**FINAL DRAINAGE REPORT
FOR
PLATTE SELF STORAGE
COLORADO SPRINGS, COLORADO**

JANUARY 2025

TNE Job No. 2419.00
County Job No. PPR2418

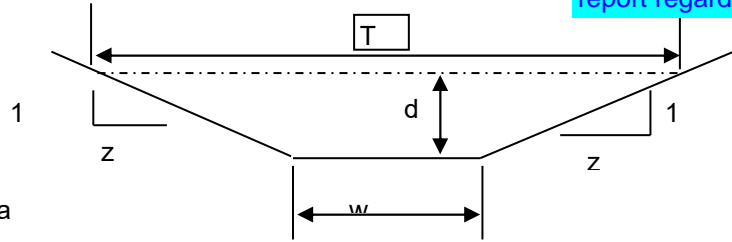
See comment on drainage report regarding side slope

Pipe ID: **18" RCP Culvert (Basin OS-W)**

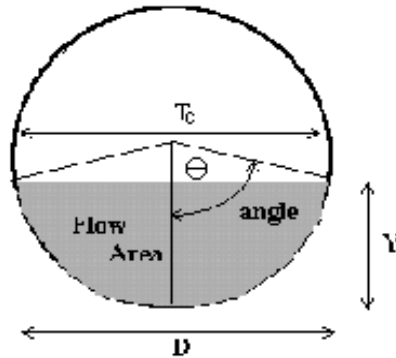
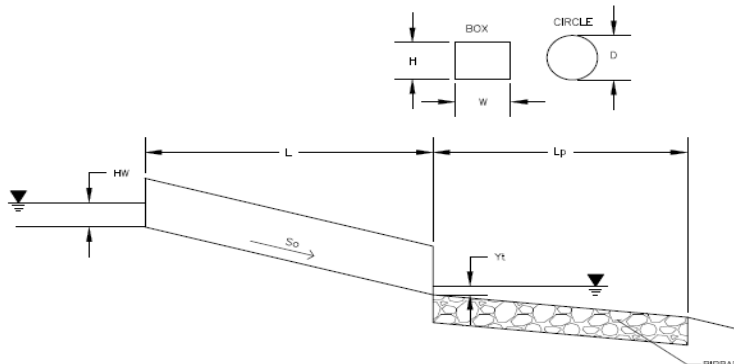
Unresolved:
 Indicate what is being done for supercritical condition. Per criteria, FR # needs to be less than 0.9.

PLATTE SELF STORAGE SITE DEVELOPMENT PLAN PROPOSED DRAINAGE MAP JANUARY 2025

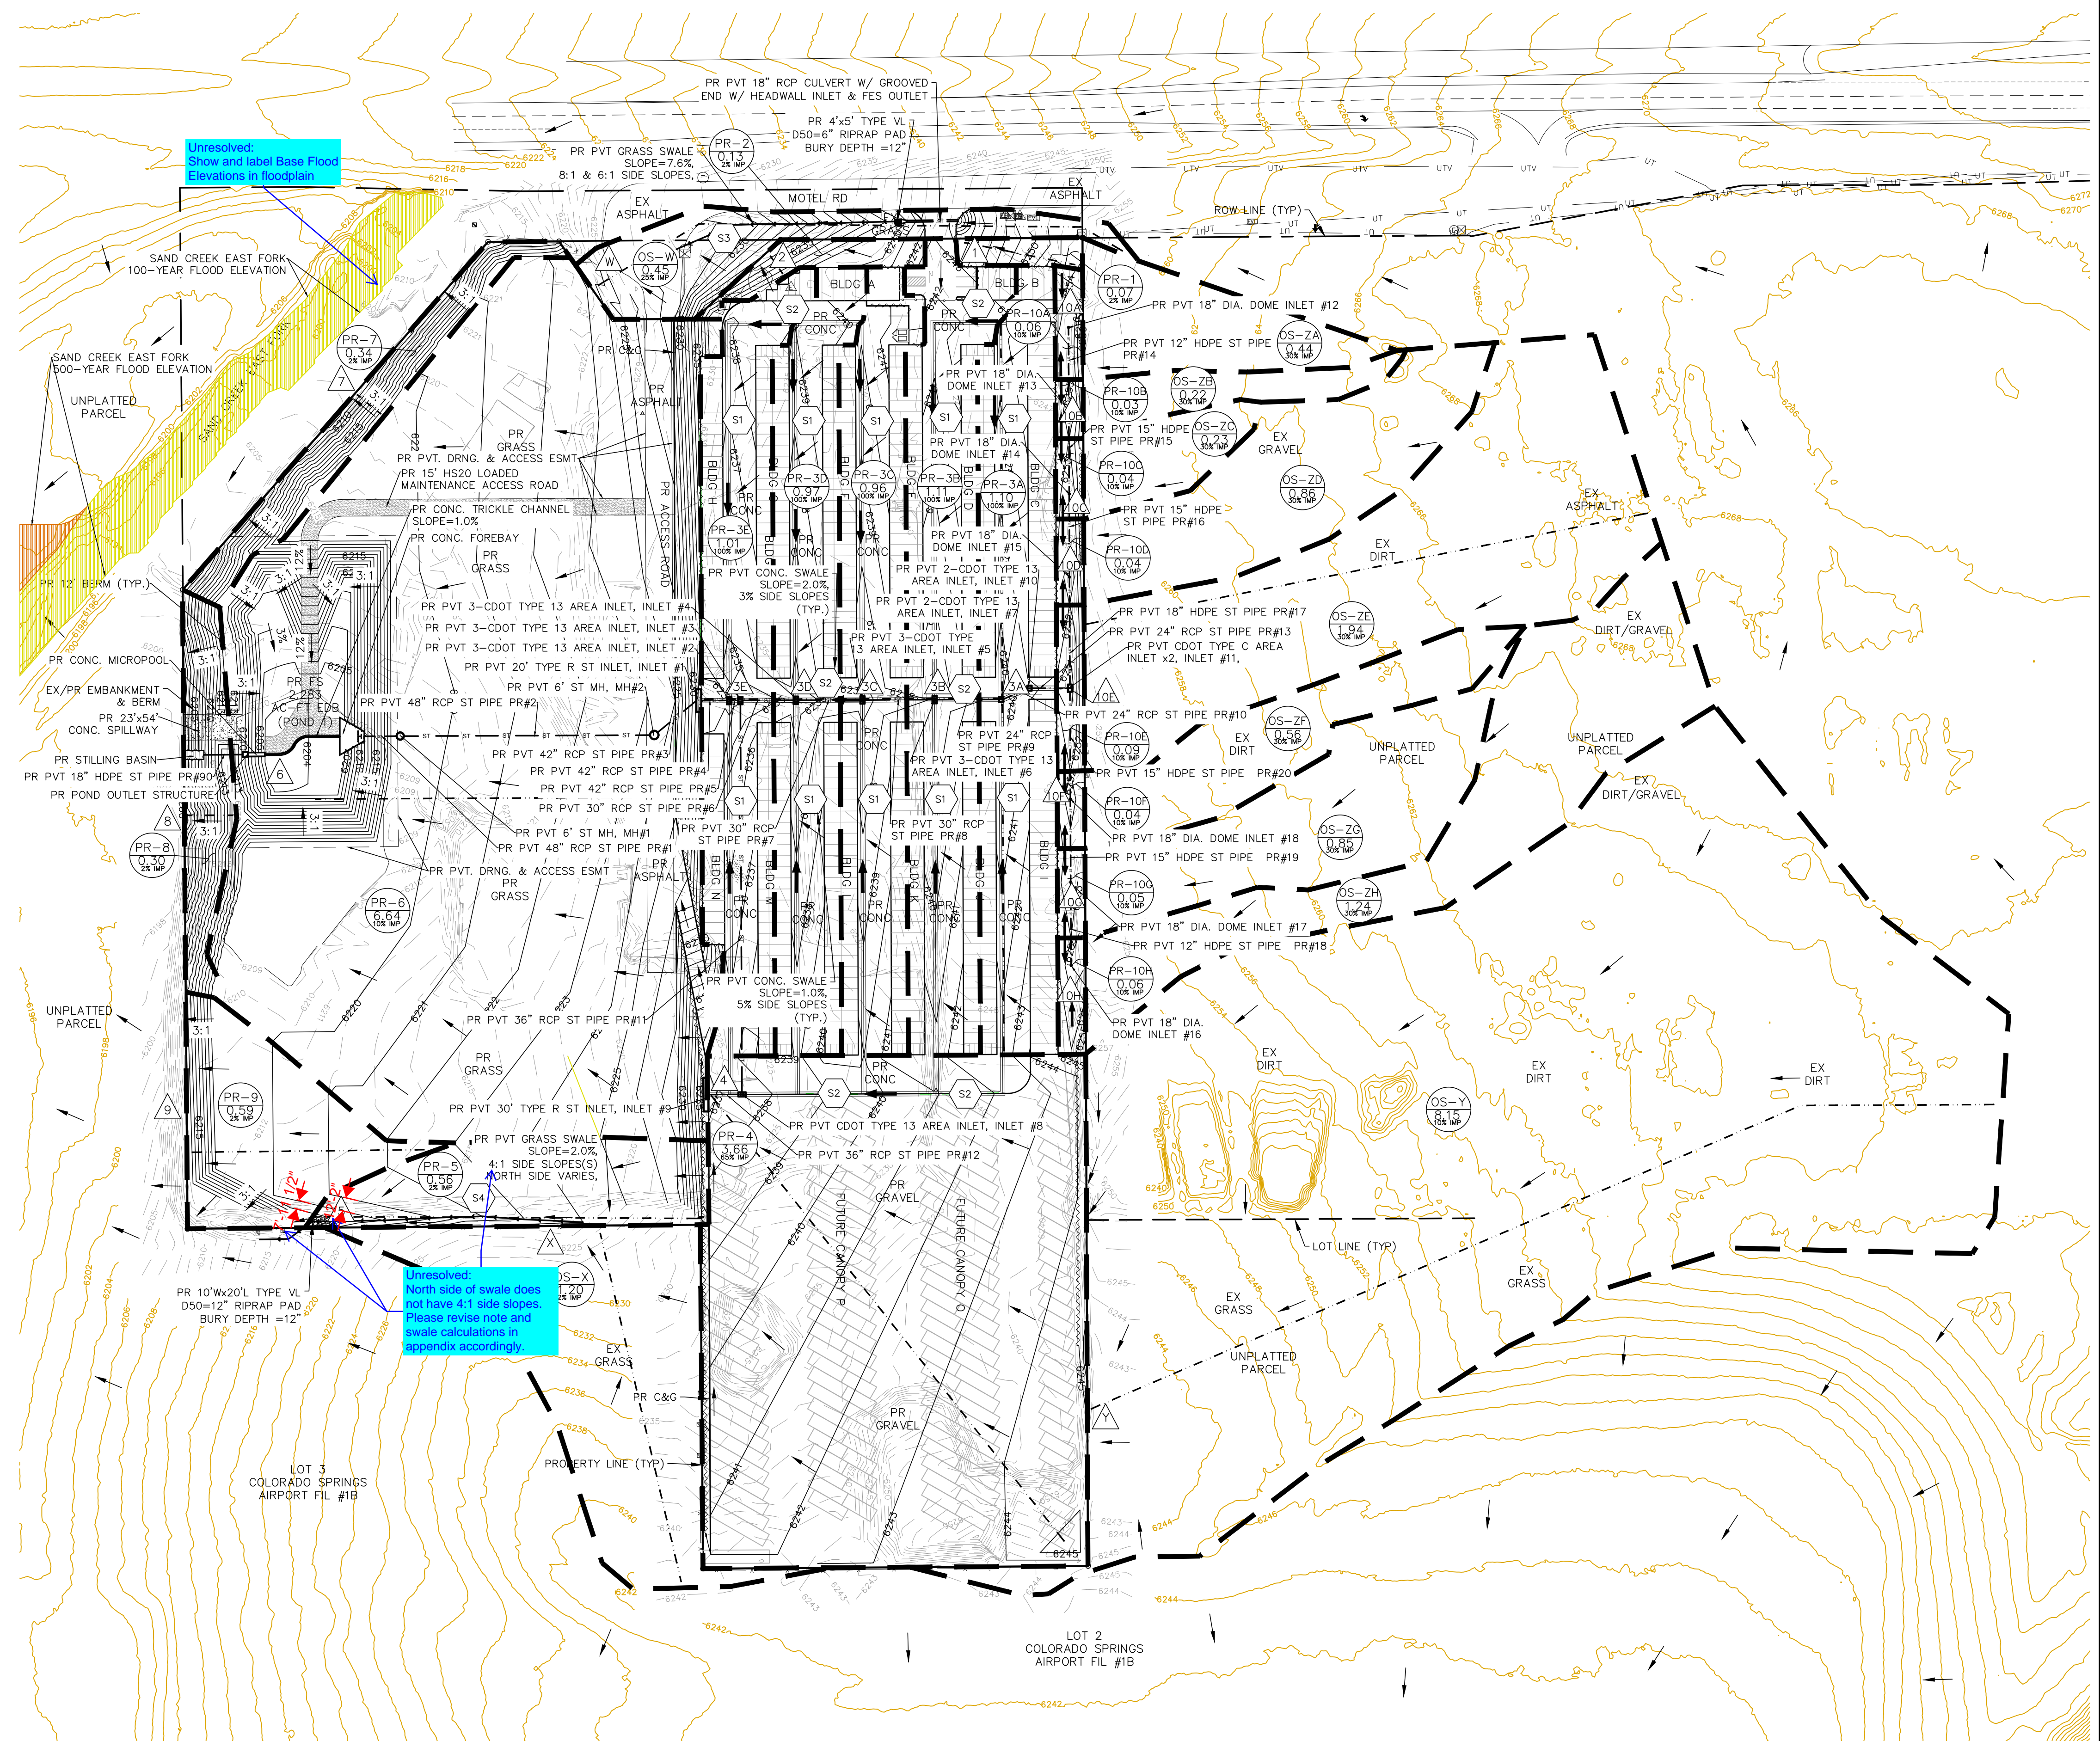
Unresolved:
Show and label Base Flood Elevations in floodplain

Unresolved:
North side of swale does not have 4:1 side slopes. Please revise note and swale calculations in appendix accordingly.

Unresolved:
Show and label Base Flood Elevations in floodplain. See floodplain exhibit for additional information.
